Integrated Iron & Steel NESHAP Presentation to OMB

February 14, 2024

COST ESTIMATES AND ECONOMIC IMPACT

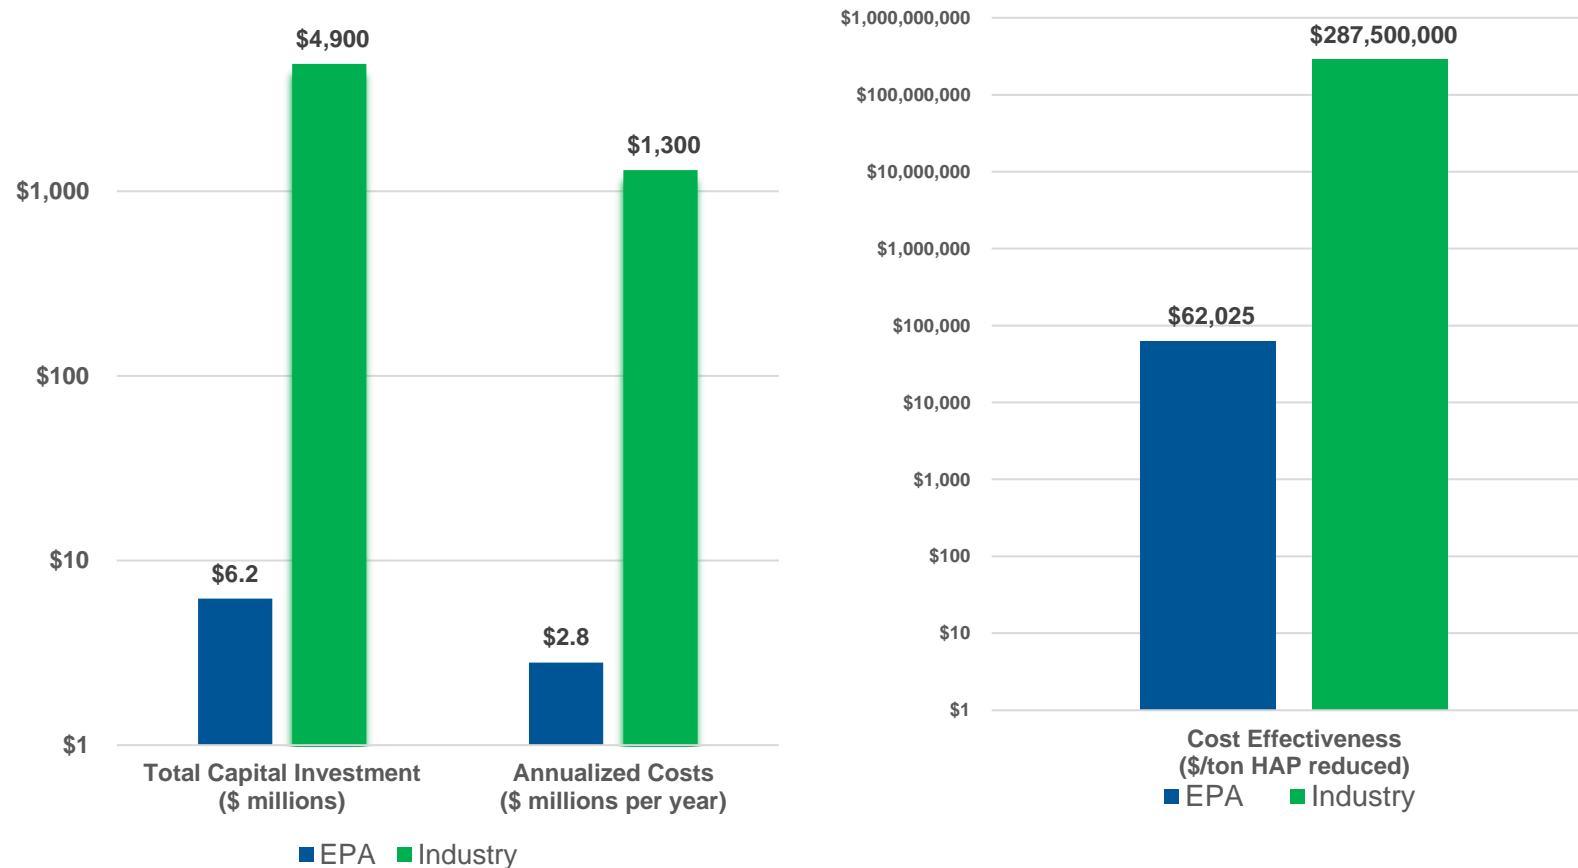
OMB should compel EPA to revise the cost estimates

EPA assumed the limits are achievable with no major investments in new air pollution control technology

- EPA estimates capital costs at \$6.2 million (with an assumption of only requiring “work practices” to comply)
- Industry estimates of \$4.9 billion in capital costs to install new controls, plus more than \$1.3 billion/year in operating costs (which may not guarantee technical achievability)

LEAD AND ARSENIC AMBIENT MONITORING TRENDS (US EPA AIRDATA)

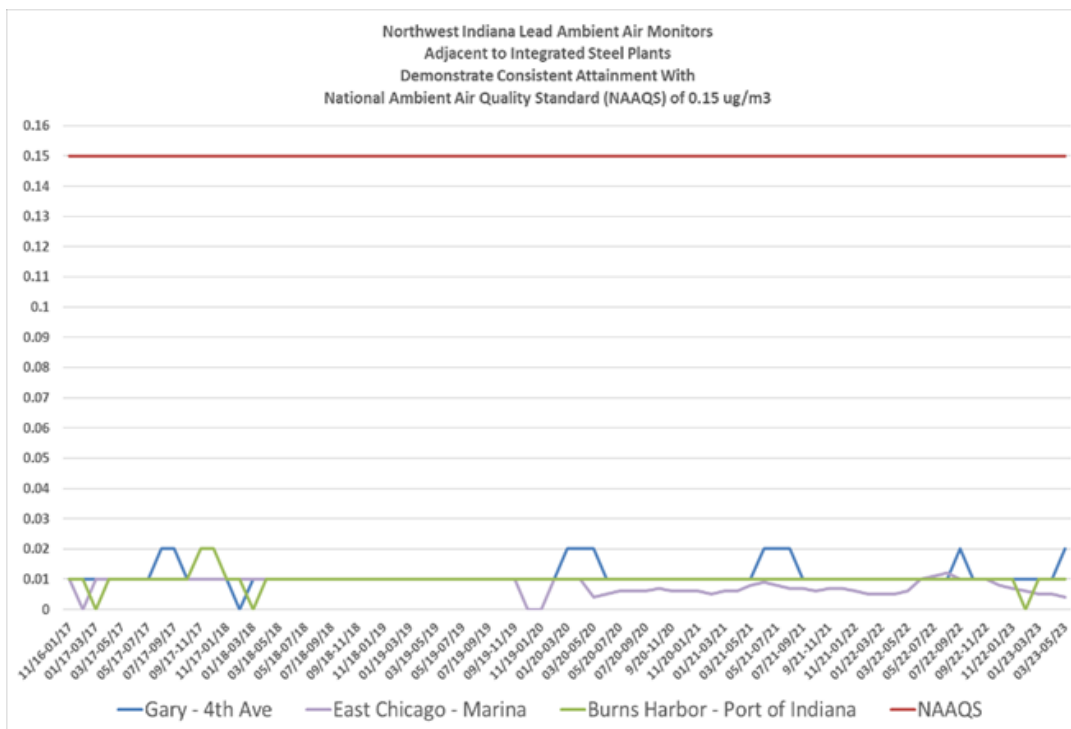
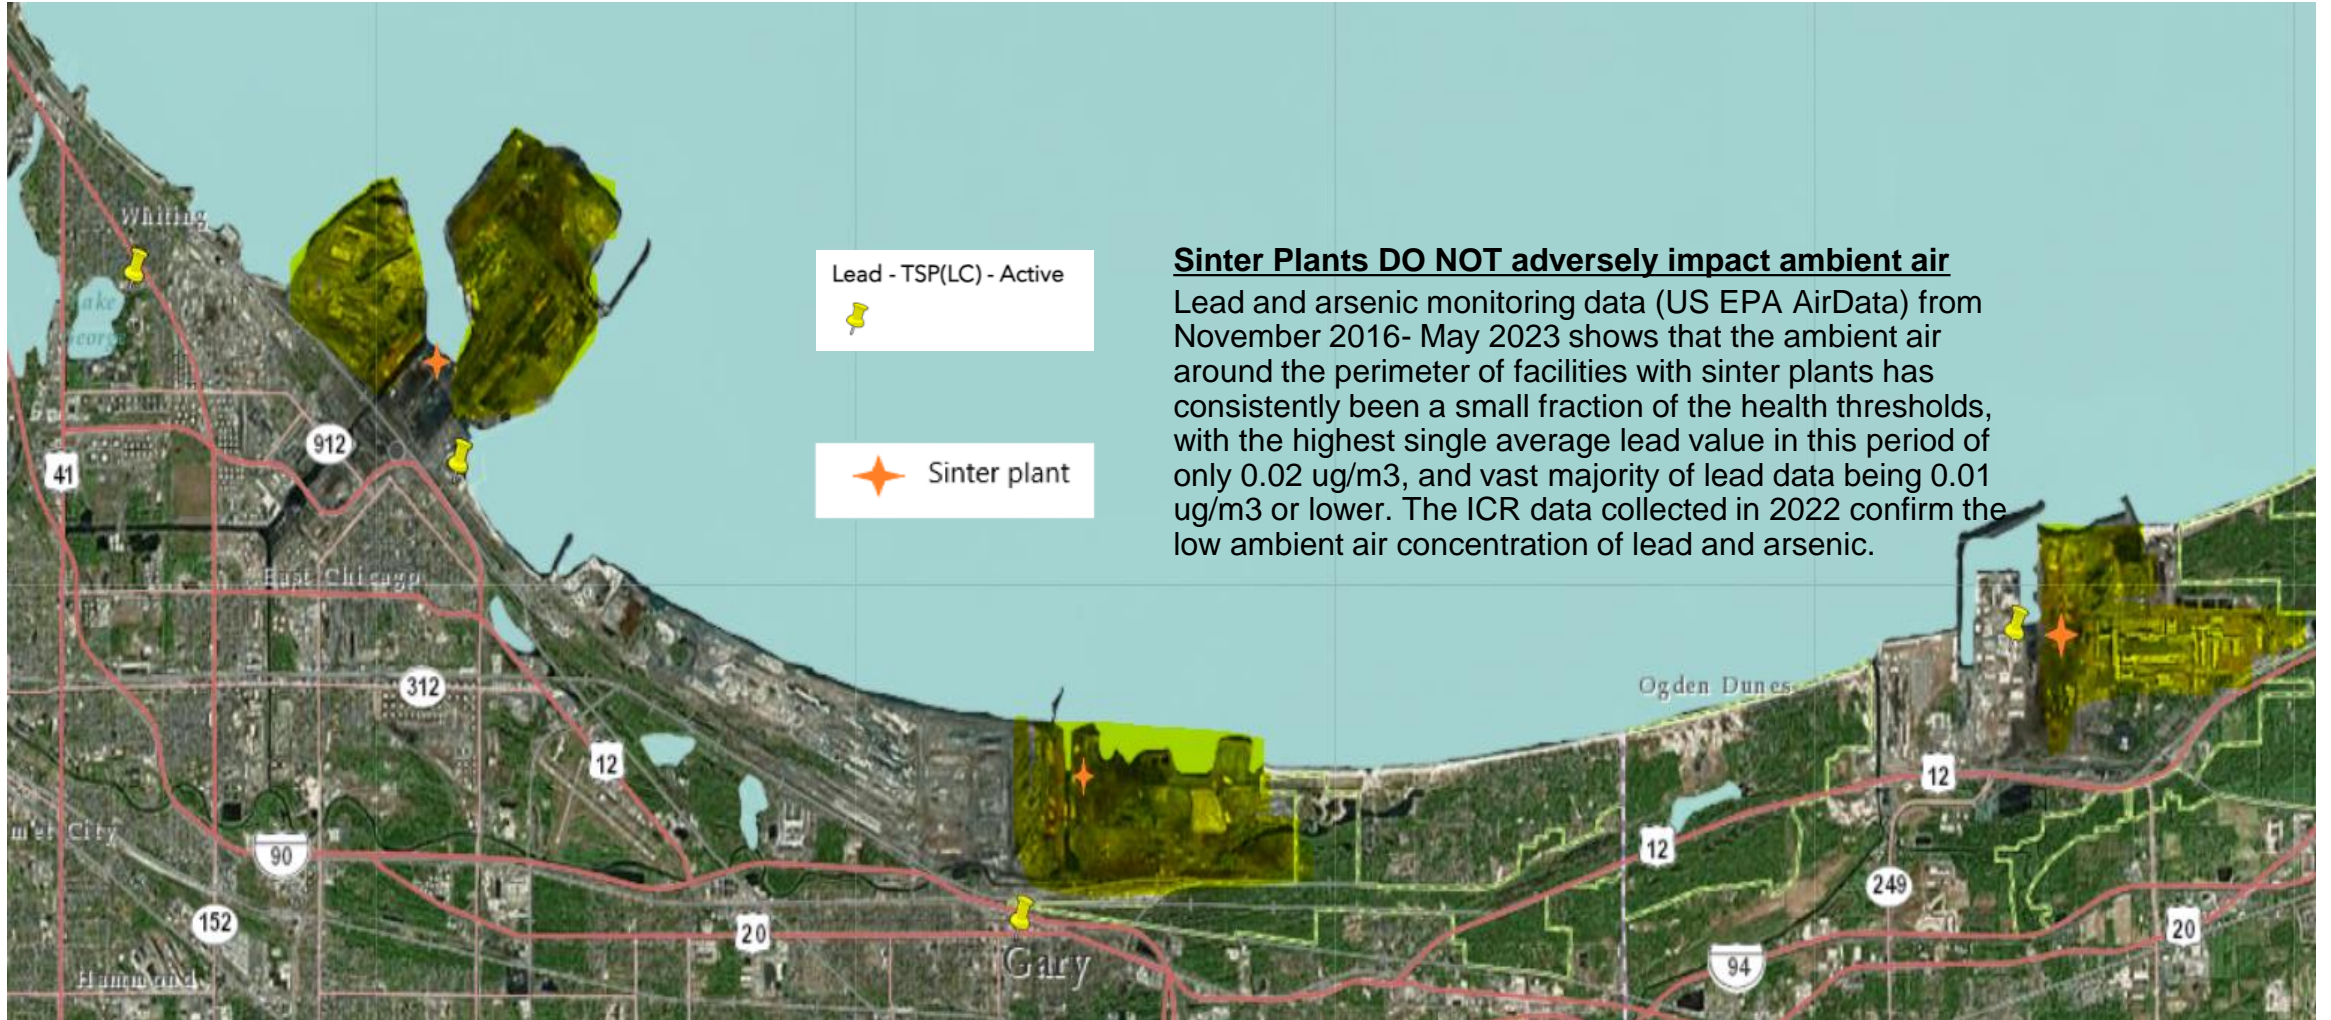
- US EPA AirData Air Quality Monitors provide relevant arsenic monitoring data to compare against risk thresholds for arsenic near steel facilities.
- Lead monitoring data from November 2016-May 2023, shows that the ambient air around the perimeter of facilities with sinter plants has consistently been a small fraction of the NAAQS limit, with the highest single average value in this period of only 0.02 ug/m³, and vast majority of data being 0.01 ug/m³ or lower.
- Arsenic monitoring data from 2017-May 2023, shows that the ambient air around the perimeter of these facilities with sinter plants has consistently been a small fraction of the arsenic risk level (shown by the red line in the below charts)
